LAKE PONTCHARTRAIN, LA. AND VICINITY
LAKE PONTCHARTRAIN BARRIER PLAN

DESIGN MEMORANDUM NO. 10,
CORROSION PROTECTION

SUBJECT: Lake Pontchartrain, Louisiana and Vicinity, Lake Pontchartrain
Barrier Plan, Design Memorandum No. 10, Corrosion Protection

PLATE 10

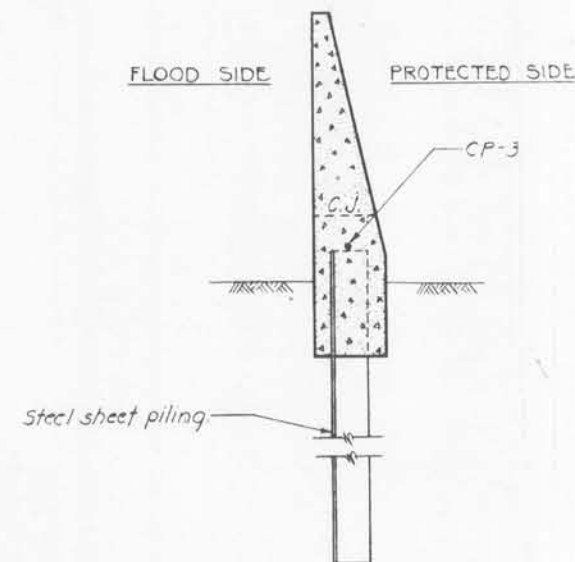
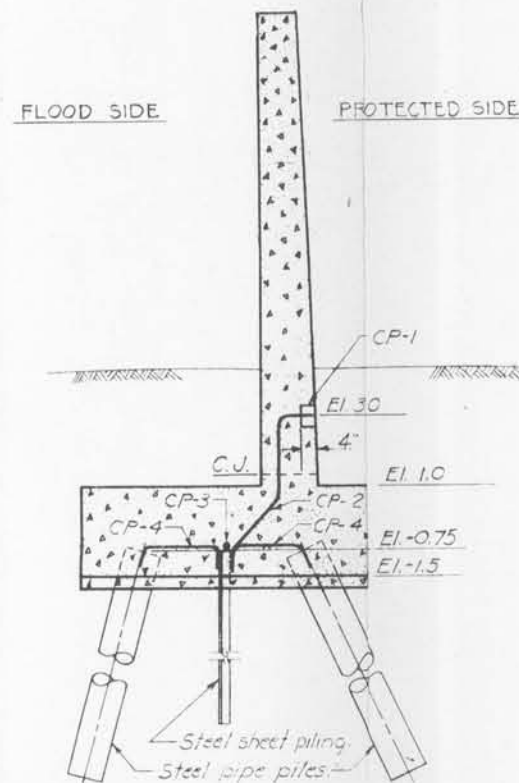
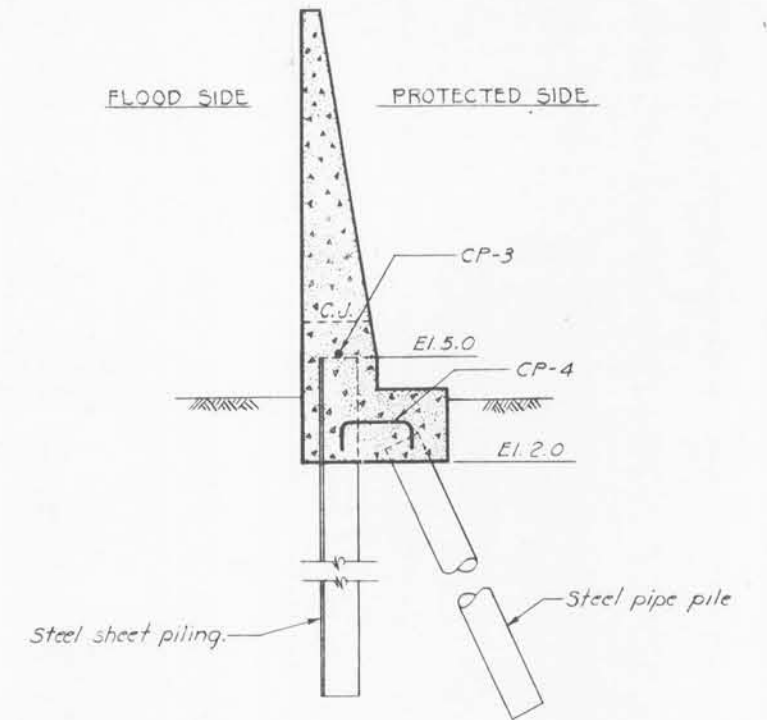
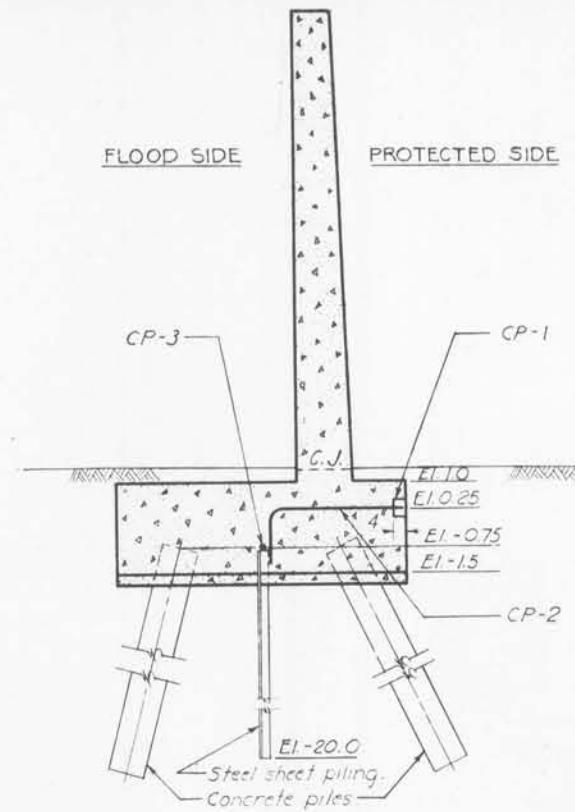
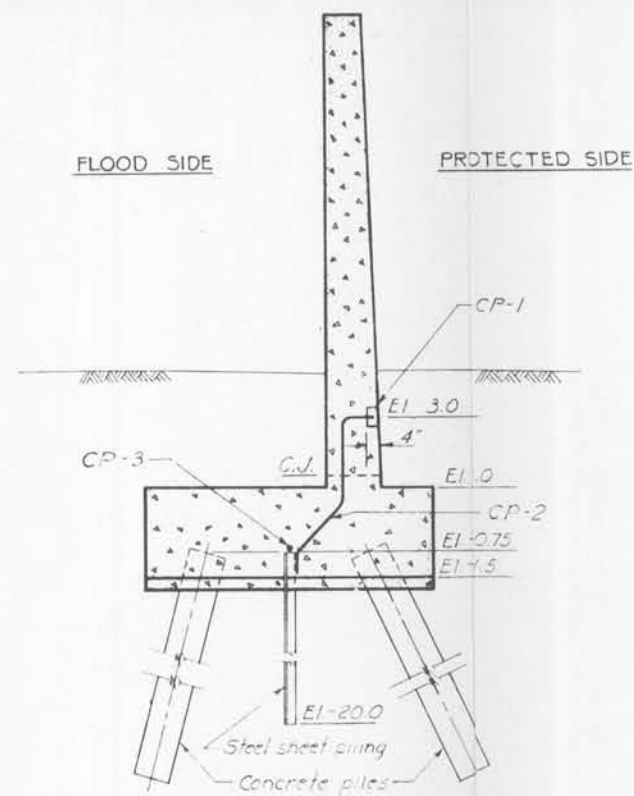
3. Plate 11. Consideration should be given to using flexible cable for CP-3 connection along the top of sheet piling to avoid problems due to piling irregularity.

(2) Paragraph 3. To date, no difficulties have been encountered
due to piling irregularity while using the No. 6 reinforcing bar for
bonding purposes. In addition, substitution of flexible cable would
result in more costly corrosion protection systems. Therefore, it is
recommended that No. 6 reinforcing bars be used for the CP-3 connection
along the top of the sheet piling as presented in the subject design
memorandum.

2. Para 1b(2) of 4th Ind. In the contract specifications, consideration should be given to permitting the Contractor, at his option, to locate the No. 6 bonding bar against the vertical face of the steel sheet piling if any irregularity in top of piling is encountered.
